PLANNING COMMISSION STAFF REPORT

Meeting: April 22, 2025

Modification to a previously approved Development Permit and Architectural & Site Approval for the Westport Development including, but not limited to, dwelling count and ground floor retail, Park Land Dedication Fees and minor changes to Building 1. (Application No(s): M-2024-003, ASA-2024-003; Applicant(s): Related California (Cascade Zak); Location: 21267 Stevens Creek Boulevard; APN #326-27-048)

Figure 2 Comparison between the approved and proposed retail portions of Building 1. Retail is filled in with red, resident amenities in orange, and Back-of-House/Support in blue.

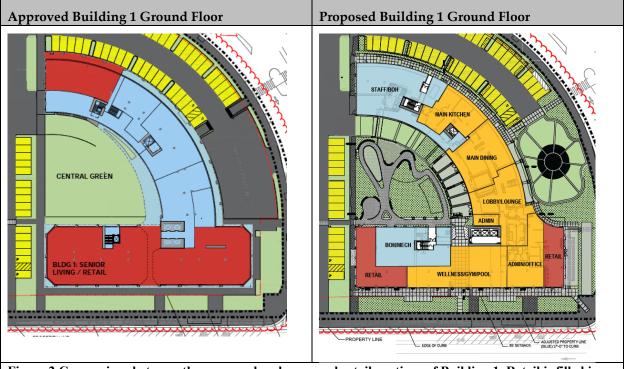
The Heart of the City Specific Plan limits the area of uses that do not involve the direct retailing of goods or services to the public to no more than 25% of the building frontage along Stevens Creek Boulevard, and no more than 50% of the rear of the building. On December 21, 2021, the City Council approved a Heart of the City Exception allowing 40% of the building frontage along Stevens Creek Boulevard and 75% of the rear of the building to be occupied by non-retail uses. There was no change approved in 2021 to the total retail square footage in Building 1 (17,600 sq. ft.) from that approved through the original 2020 permit.

The applicant submitted a letter, dated June 18, 2024 (Attachment C), stating that since their application is a modification to the overall Westport Development project, the developer of Building 1 remains eligible for the second of two allowable State density bonus law incentives and concessions allowed for the 8.1-acre Westport Development. Therefore, the developer requests to use the second available incentive and concession to reduce the required ground floor retail in Building 1³.

As illustrated in Figure 3, the proposed retail locations are on the corner of Building 1 adjacent to Mary Avenue, as well as the development's driveway entrance along Stevens Creek Boulevard. The other uses along Stevens Creek are active and administrative uses limited to resident access, including the front office and wellness center for the senior assisted living facility.

The applicant suggests that the spaces currently entitled as a retail area in Building 1 occupy ground floor building space that could otherwise be used for mechanical systems and back-of-house spaces for the senior assisted living facility. The currently proposed locations for these uses are in more expensive-to-build basements or upper-level building locations.
